From: Oswald, Hank
Sent: Tuesday, March 1, 2022 2:43 PM
To: Family Puciloski
Cc: Blotzer, William; Freemon, Robert; Silvast, Zackary; Williams, Jeffrey
Subject: RE: Site Visit_6032 Jerrys Drive

The latest building permit site plan was co-reviewed by both the Deputy Director (Jeff Williams) and Director (Mike Davis) of Environmental Health. In short, the site plan cannot be approved as shown, because the garage was built inside the sewage disposal area (SDA). Per the signed plat of 1995, improvements of any kind are restricted in this area until connection is made to public sewer.

6/2024
6032 Jerrys Drive
Columbia, MD 21044
Septic Tank Abandonment

A50442A
COUNTY#

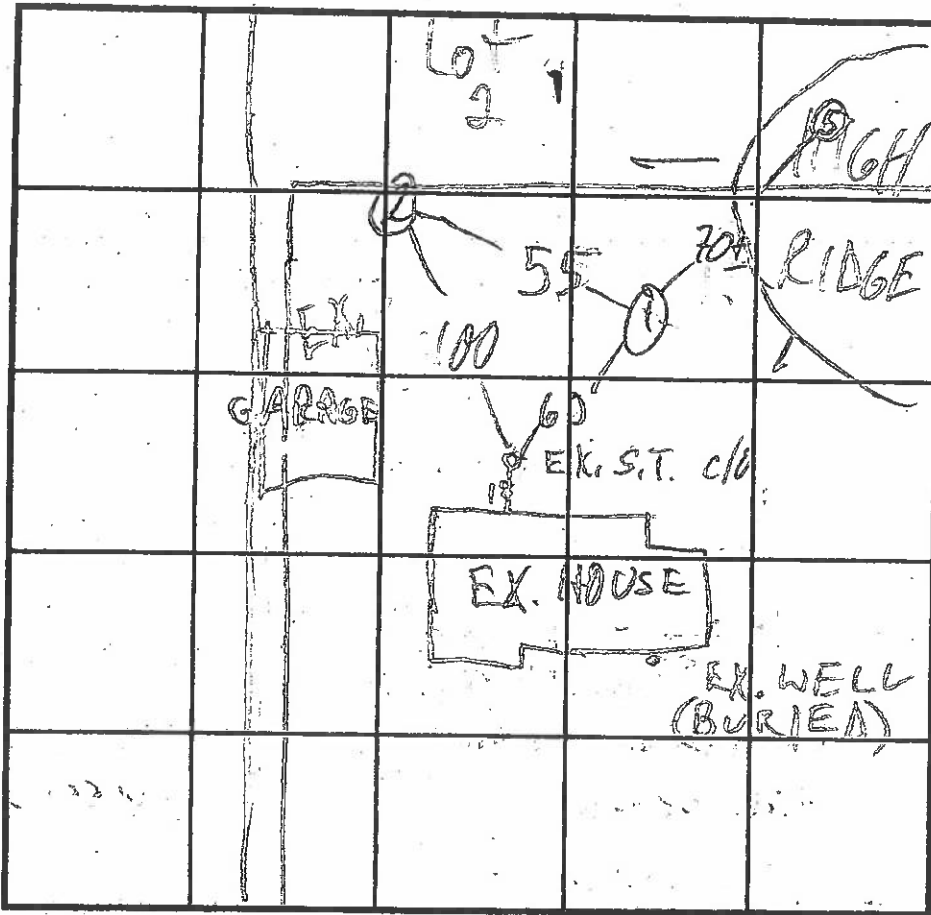
Yes, I received the site plan. I have a follow-up question. How did you come up with the location of the existing trenches, because there is a plan in the septic record that shows the trenches in a different location (please see attachment)?

A 50443B

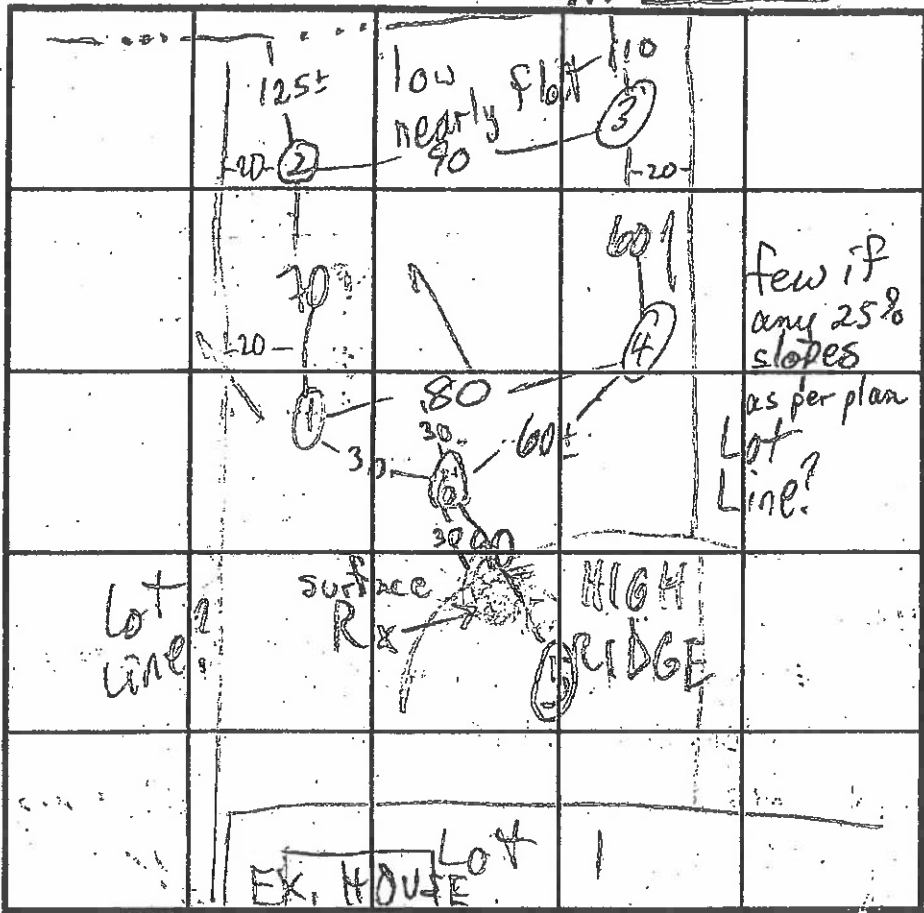
REMARKS: HOLE ③ HAS H₂O @ 10 1/2; OTHERS ALSO OF CONCERN

Percolation testing conducted January 9, 1995 on the above referenced property indicated limited satisfactory soil conditions. Shallow water table was encountered in one of the lower test holes; soil profiles in other test holes were suggestive of potential water table limitations. Copies of the percolation test results are enclosed.

Further review is contingent upon submission by a registered engineer of a percolation certification plat showing actual locations and elevations of all excavated test holes and a suitable house and well site. The plat should also include the location of all existing wells and septic systems on the property as well as the location of any other relevant features such as streams, swales, or existing structures. A note must be included certifying that all wells and septic systems within 100 feet of property boundaries have been shown. It is requested that the land surveyor provide confirmation of any 25% slope within the proposed sewage area or within 25 feet of that sewage area.

It is suggested that the sewage easement be platted as high on the lot as possible. Follow-up testing in the wet season may or may not be necessary prior to a final determination.

A50443A
COUNTY #

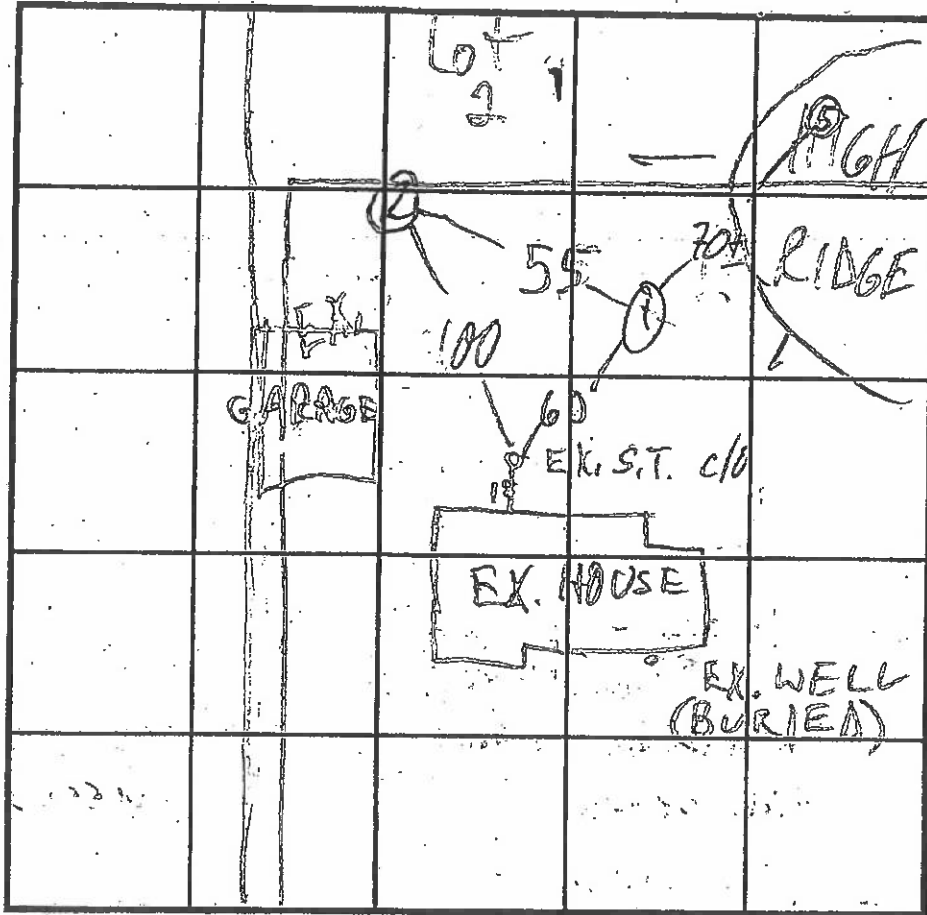
APPLICANT AWARE THAT
ADEQUATE SITE CONDITIONS
FOR WELL & SEPTIC ON BOTH LOTS
WILL BE DIFFICULT TO ACHIEVE,
MAY BE ABLE TO TAKE DE
PUBLIC/PRIVATE
FACILITIES TO
MEET MIN. REQUIREMENTS

THEN WHY NOT ALL PUBLIC? (CW)
